Detailed Site Plan Dunkin Donuts Clinton

DSP-20018

SUBJECT: Detailed Site Plan DSP-20018
 Dunkin Donuts Clinton

Figure 1: Proposed East and South Elevations

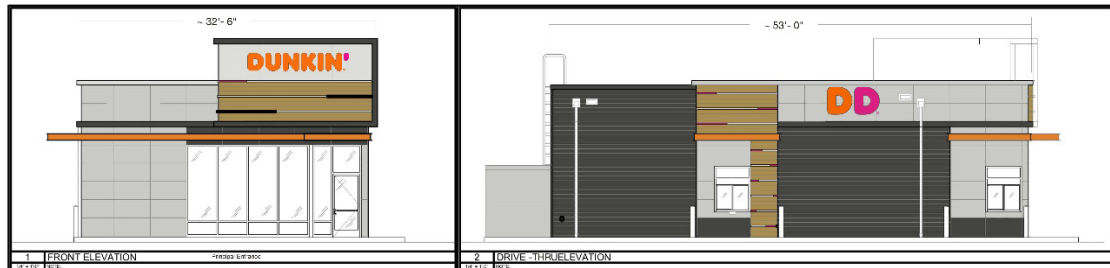
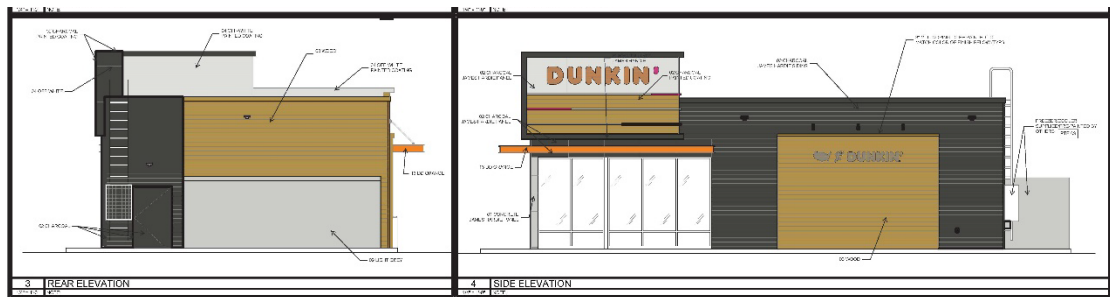
The proposed architectural elevations propose a contemporary franchise look and feature a modern grey color scheme with accents of brown, orange, and pink. Visual elements faced with hardie plank siding, wood slats, and concrete panels are shown on the front façade and each side of the building. These elements will provide dimension and visual interest, with the main entrance to the building accented by glass panels and signage. The roof of the building is generally flat, with various levels across the building face to provide visual interest. The building will feature flat metal canopies above the window line across the front façade and along each side façade to the entrances, as well as over each drive-through window.

A total of four building-mounted channel letter style signs are proposed, with two located on the north façade, and one on the east and south façades. The north and east façade signs include the Dunkin name over the entrance vestibules and the corporate 'DD' logo is proposed on the south façade. The building-mounted signs measure approximately 5 to 12 square feet and have been found acceptable. However, due to the number and variety of signs proposed, a sign table is recommended to show conformance to the requirements of Sections 27-613 and 27-614 of the Prince George's County Zoning Ordinance, as conditioned herein.

- h. Correct the Zoning Ordinance Sign Sizing Note on Sheet 1 to reflect the freestanding sign height and area proposed.
- i. Provide a signage area table demonstrating how the building-mounted and freestanding signs conform to Sections 27-613 and 27-614 of the Prince George's County Zoning Ordinance.
- j. Provide the height of the sign proposed above the roof line to demonstrate that it is in conformance with Section 27-613(b)(1) of the Prince George's County Zoning Ordinance.
- k. Provide all the signage dimensions and measurements in decimal values to maintain consistency in the DSP.
